PROJECT TITLE AND LOCATION: Modified MOUT and Range Upgrade Facility, Ft Wainwright, Alaska

W911KB-04-B-0002 Amendment 2
FTW 254 Modified MOUT and Range Upgrade

FTW254 CONTRACTOR QUESTIONS

Fort Wainwright Small Arms Borrow Pit Expansion Plan PHASE I

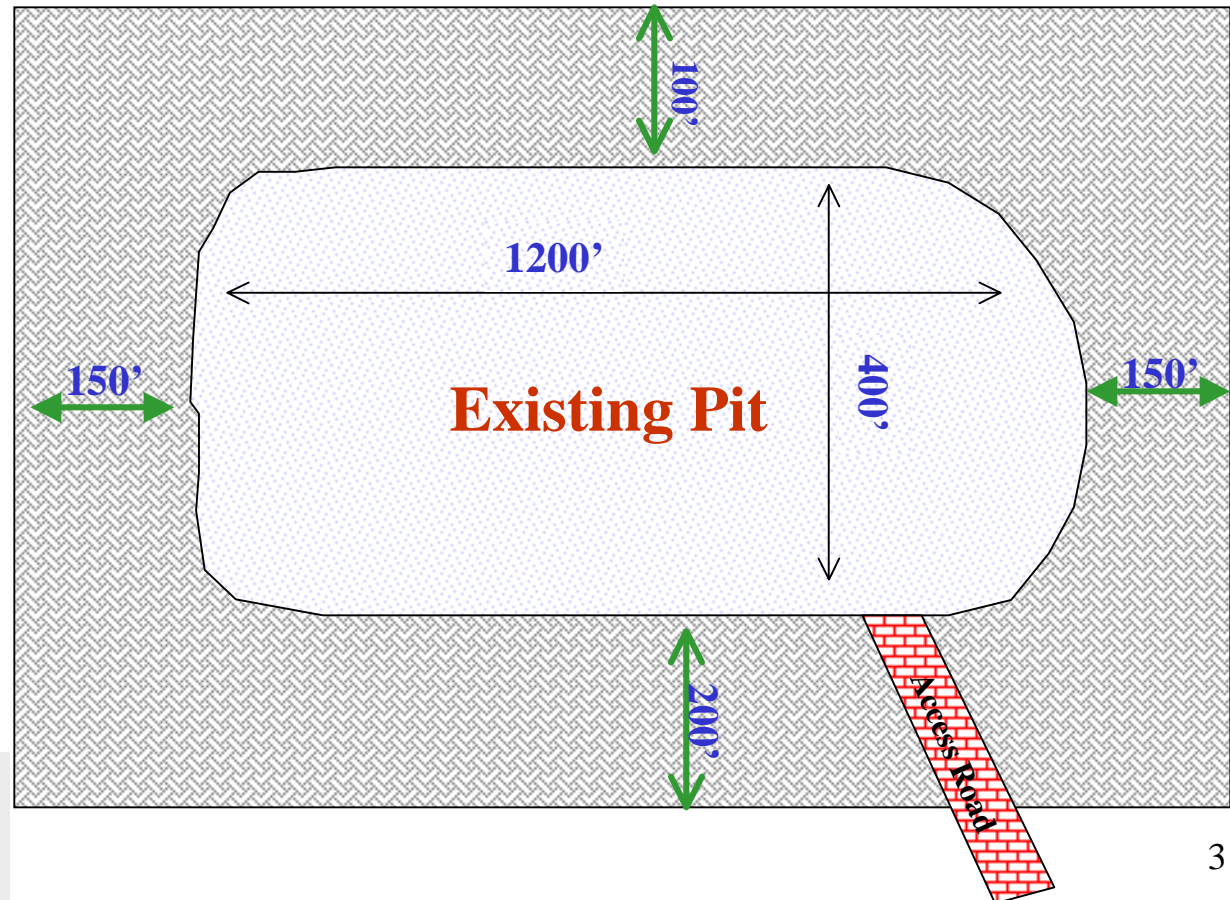
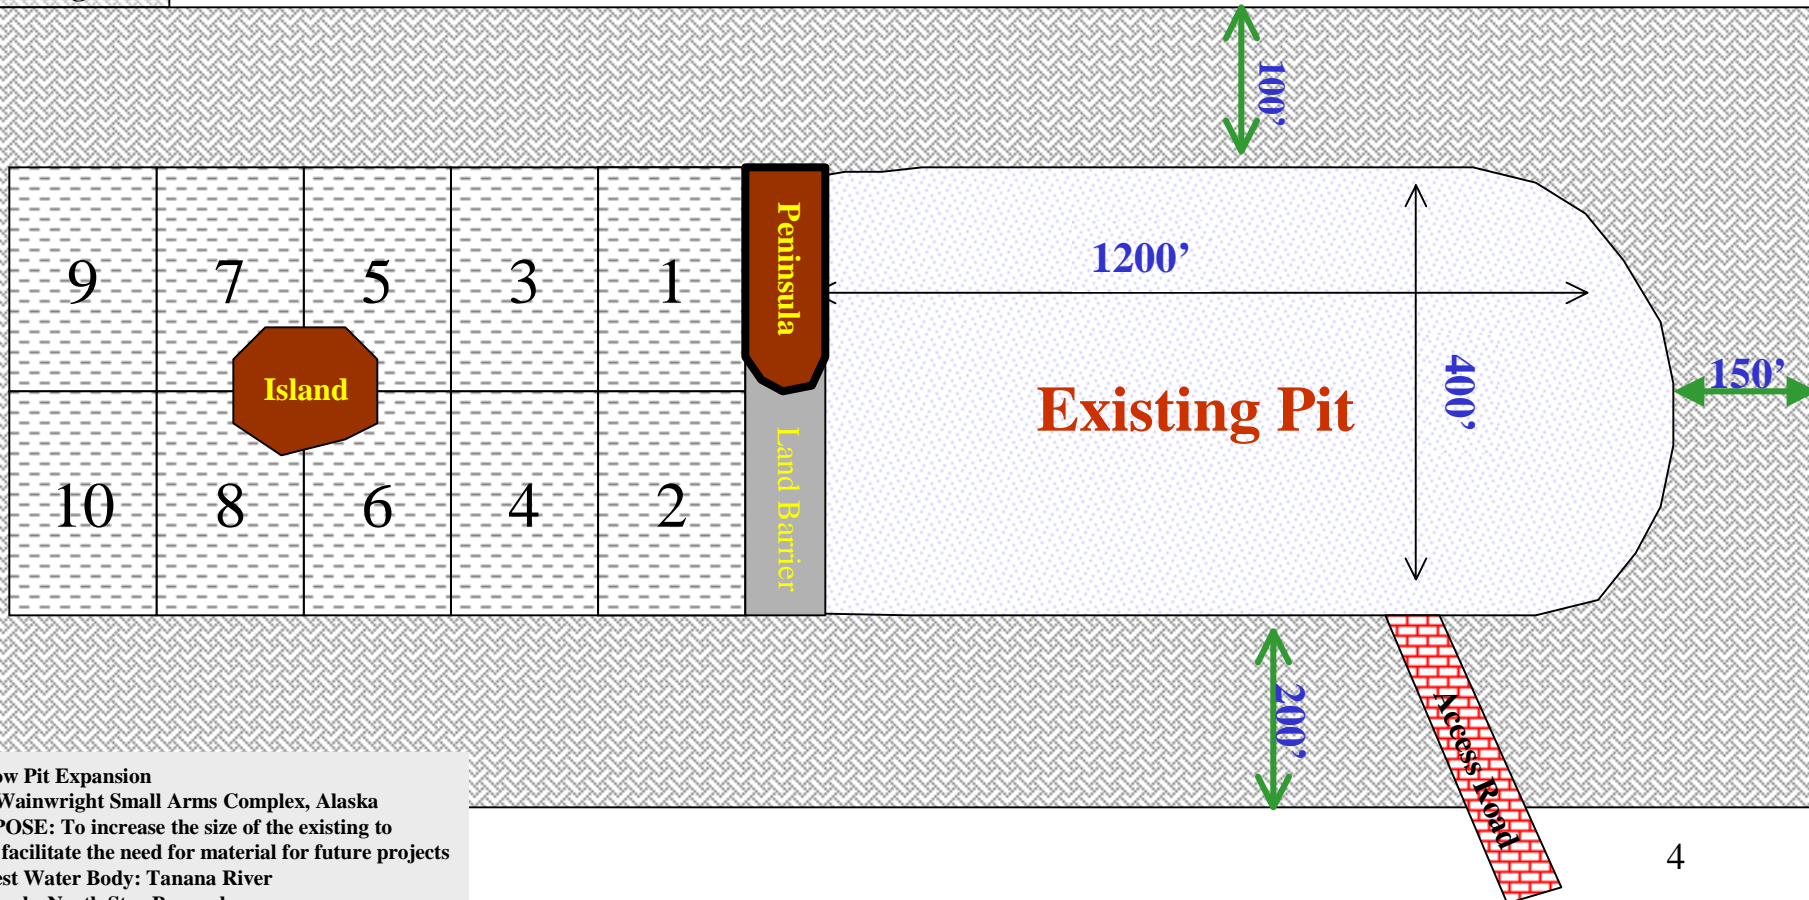
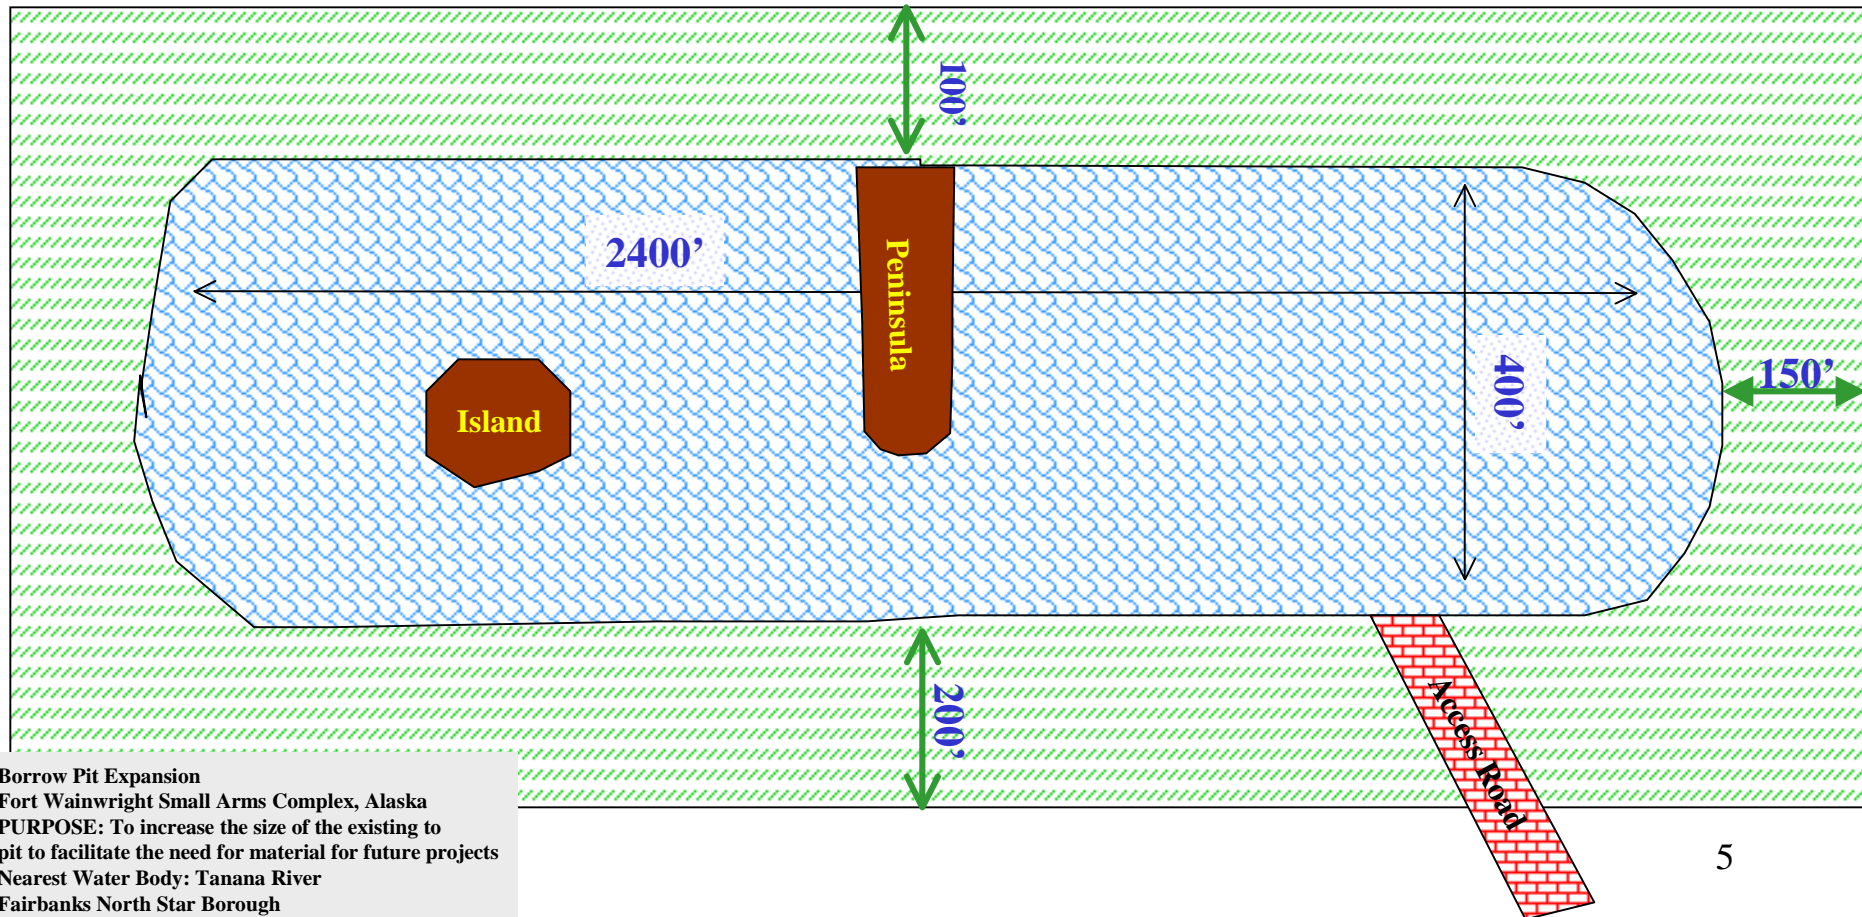
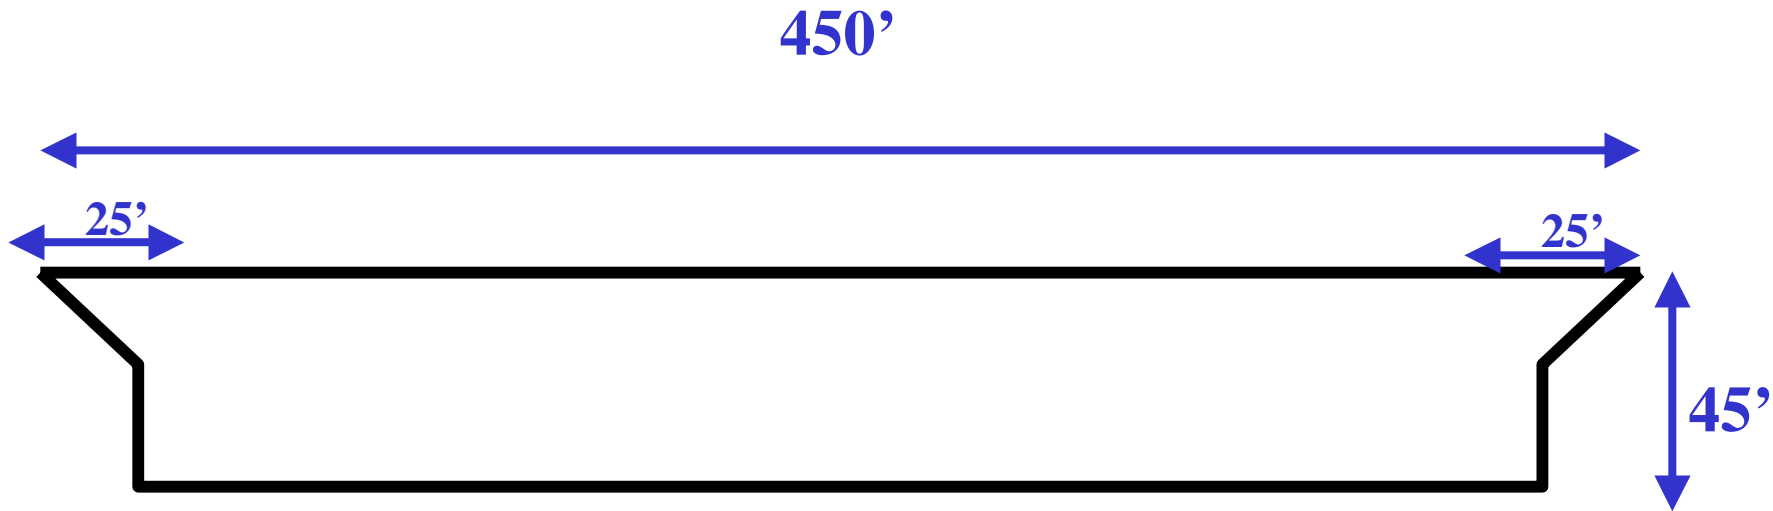
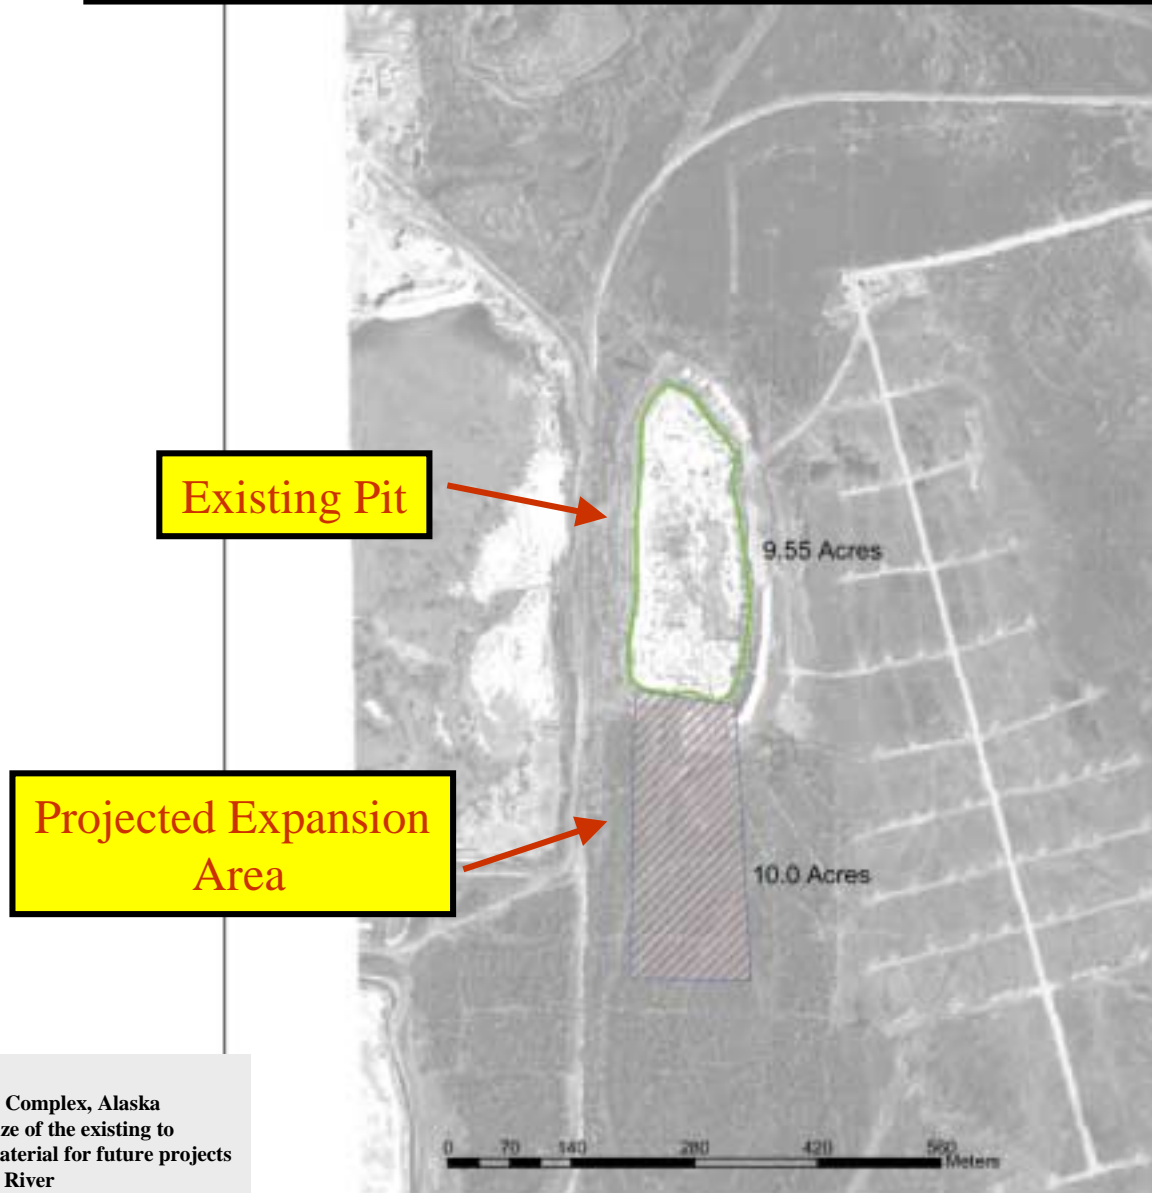
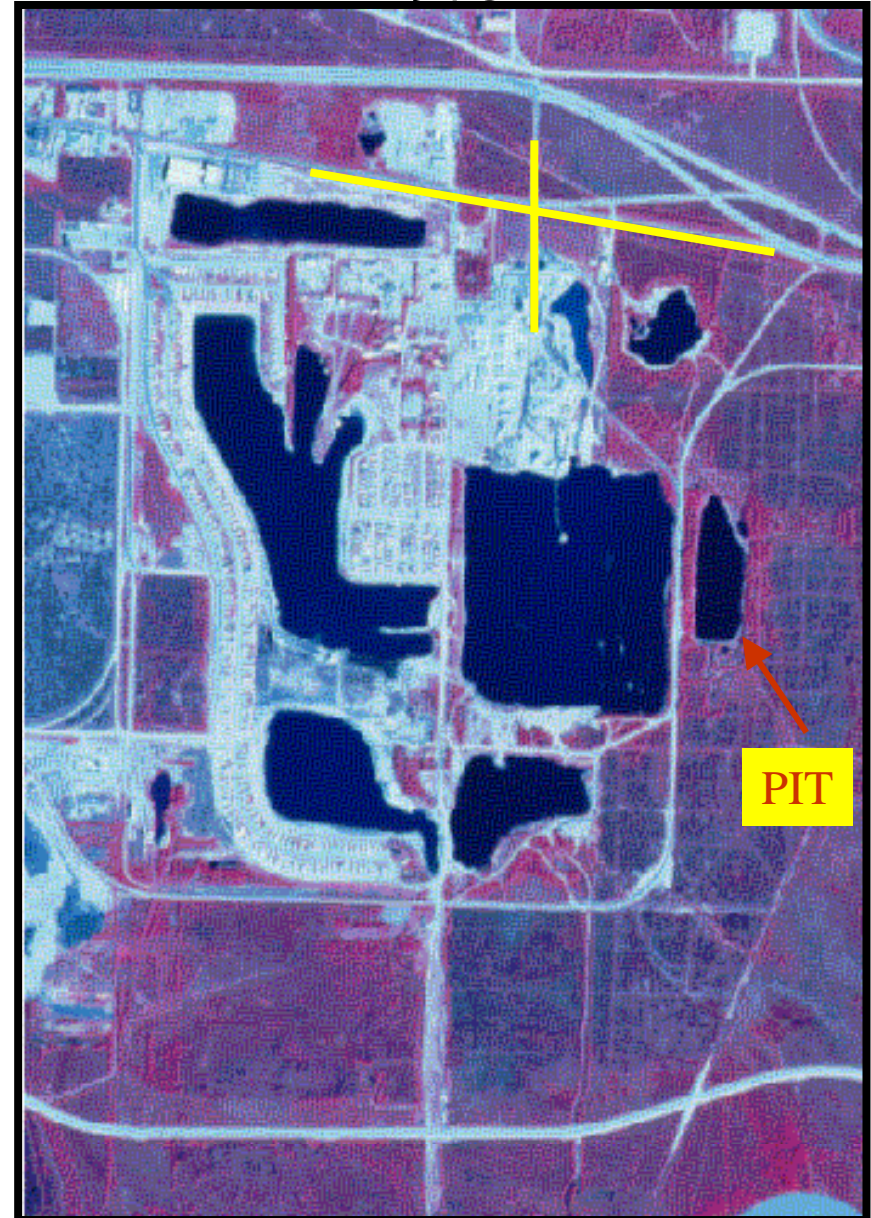
47. During the site visit we were shown an area that has been cleared, stripped and was ready for gravel bailing. I overheard someone state that we would not be able to utilize the prepared area for this contract, that we would have to prepare another area several hundred feet to the south that has not been prepared. The drawing (sheet LV-002) does not provide enough detail to determine exactly where we will be required to operate and what work will be required to facilitate mining. Please provide a detailed description of what area will be available, a mining plan, and any available geotechnical information in order to determine the amount of work that will be required to satisfy the needs of this project.

52. The area that we were shown as available for the YTA Borrow Pit was about 1.3 miles from Quarry Road. The YTA Borrow Pit Location indicated on sheet LV-002 is approximately 1/2 mile from Quarry Road. Please clarify which location will be provided for the YTA Borrow Pit Location, along with a mining plan, and any available geotechnical information in order to determine the amount of work that will be required to satisfy the needs of this project.

Refer to borrow pit plans provided under this amendment.

Refer to borrow pit plan for Mullins Pit provided under this amendment.
